Device **TC23x**
Marking/Step **ES-AC, AC**
Package **see Data Sheet**

10210AERRA

This Errata Sheet describes the deviations from the current user documentation.

Figure 3 Message RAM Configurations

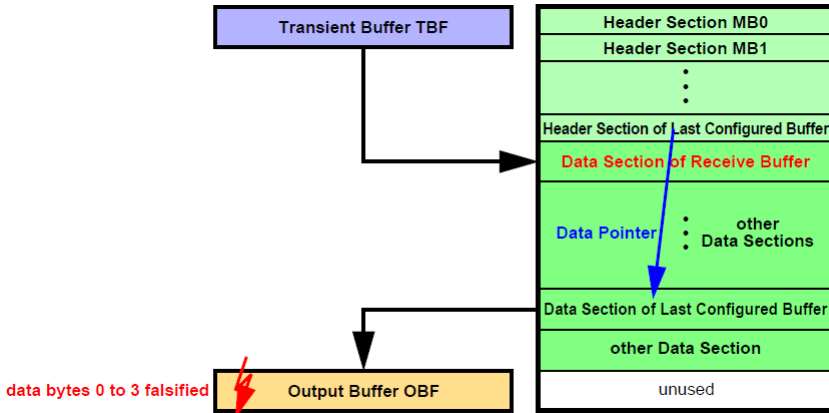
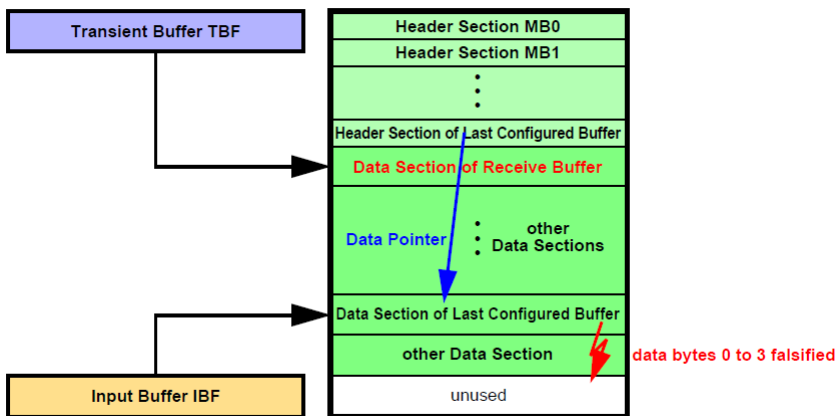
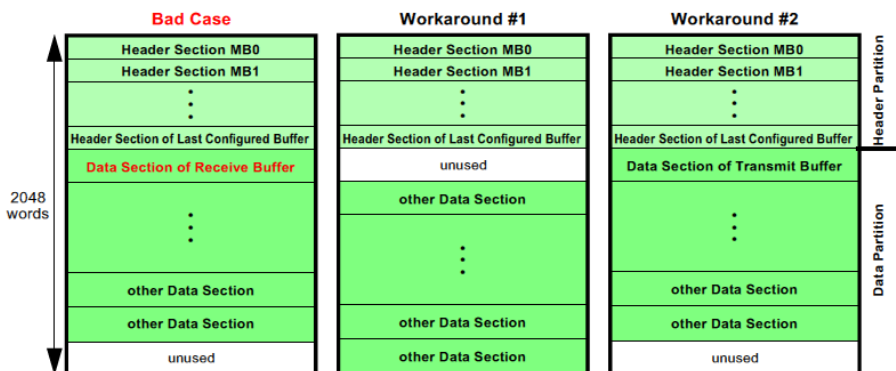
When the message buffer has its payload configured to maximum length (PLC = 127), the OBF word on address 00h (payload data bytes 0 to 3) is overwritten with unexpected data at the end of the transfer.

After the Data Section of the selected message buffer in the Message RAM has been written, one additional write access overwrites the following word in the Message RAM which might be the first word of the next Data Section.

- a) When a message is transferred from the Last Configured Buffer in the Message RAM to the OBF and **PLC = 127** it may happen, that at the end of the transfer the OBF word on address 00h (payload data bytes 0 to 3) is overwritten with unexpected data (see [Figure 1](#)).
- b) When a message is transferred from IBF to the Last Configured Buffer in the Message RAM, it may happen, that at the end of the transfer of the Data Section one additional write access overwrites the following word, which may be the first word of another message's Data Section in the Message RAM (see [Figure 2](#)).

2) Ensure that the Data Section directly following the Header Partition is assigned to a transmit buffer.

Figure 5 Transmitter - losing CAN FD node

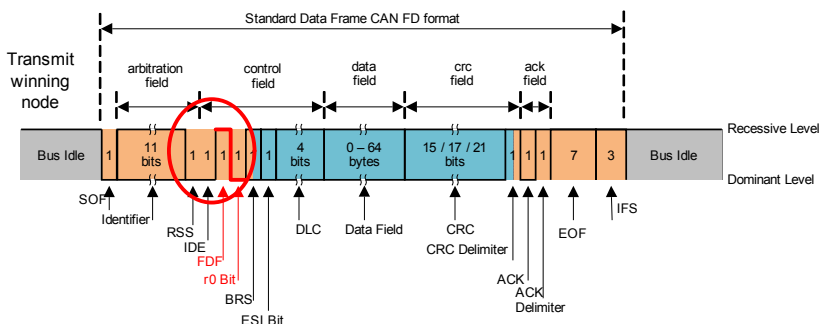
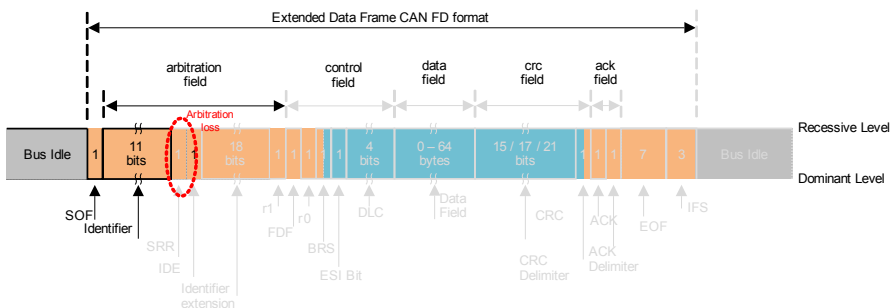
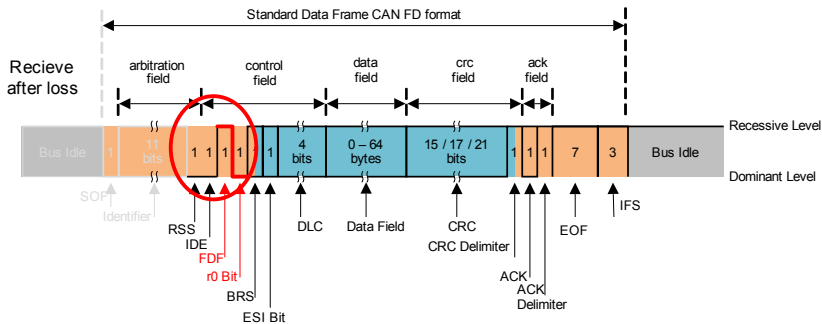
If a transmitter is losing arbitration late (e.g. in an extended frame - see [Figure 4](#) the node which wins arbitration and [Figure 5](#) the transmitting node losing arbitration), then the FDF bit to res bit is the last chance to synchronize to the

winning node (here as a receiver **Figure 6** the same node as in **Figure 5**). A timing offset will occur between the now receiving node and the actual transmitter.

The device is producing more error frames within a network than a device with a hardsync at the FDF bit.

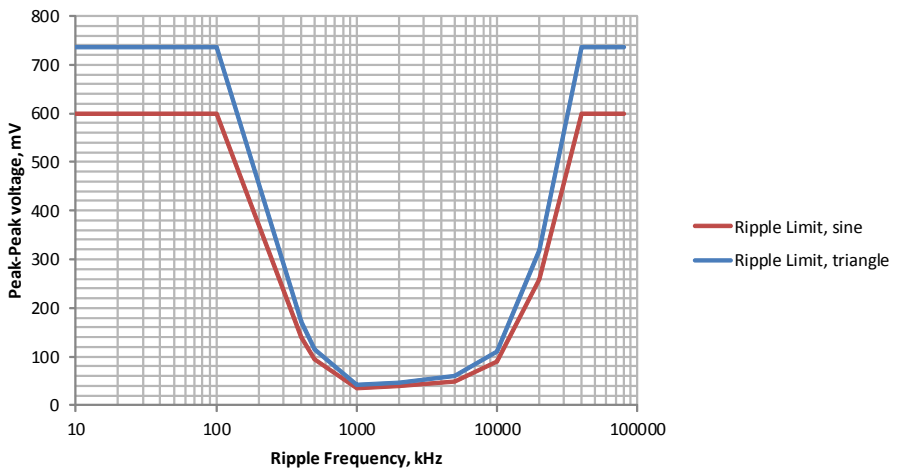
Wake-up timer usage with $\text{PMSWCR3.WUTDIV} = 1_{\text{B}}$ (10 ms count) for PMSWCR3.WUTREL values up to 20 ms is exposed to synchronization issues. The WUT counter PMSWUTCNT.WUTCNT is counted down to 0 every 10 ms, and reloading of WUTREL happens 10 ms later. If Standby request is sent before reloading PMSWCR3.WUTREL , regardless of $\text{PMSWSTATCLR.WUTWKPCR}$, wake-up request is issued without counting down. This leads to immediate wake-up.

Use WUT with setting $\text{PMSWCR3.WUTDIV} = 1_{\text{B}}$ only for longer time periods (more than 20 ms).

For shorter periods the 10 μs clock should be used with setting $\text{PMSWCR3.WUTDIV} = 0_{\text{B}}$ (default after reset).

Figure 13 Short Serial Message, Serial Data Encoding over 16 messages

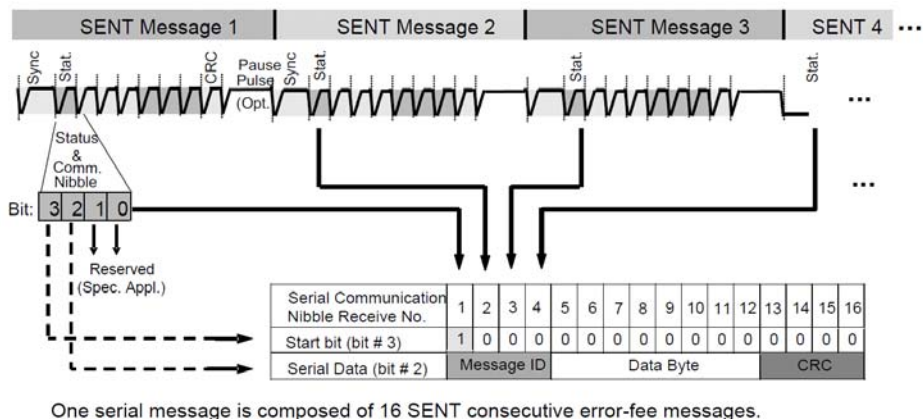
Figure 13 shows a corrected version of this figure.
